Technical Service Bulletin

74 Seat pneumatics system activates without driver input

74 14 20 2035757/3 June 2, 2014. Supersedes Technical Service Bulletin Group 74 number 14-17 dated February 21, 2014 for reasons listed below.

Figure 4. Example of DTC set for the control module after SVM code is performed.

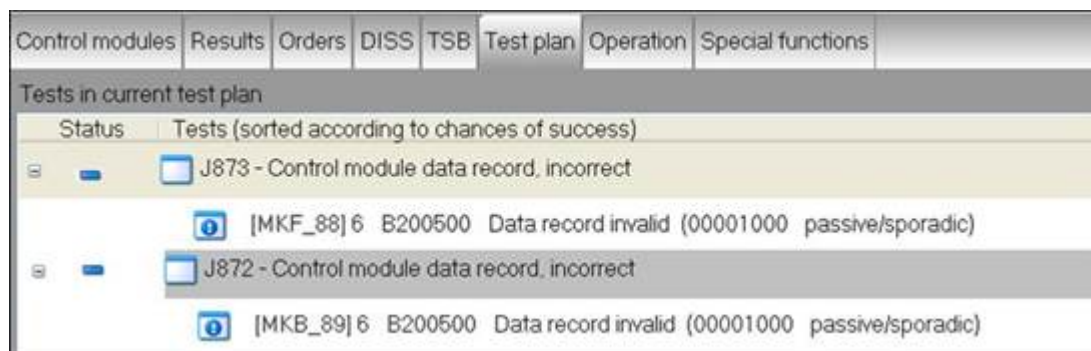
- After the SVM code is performed, one DTC will be set for each control module (Figure 4). Clear the DTCs before finalizing the procedure.
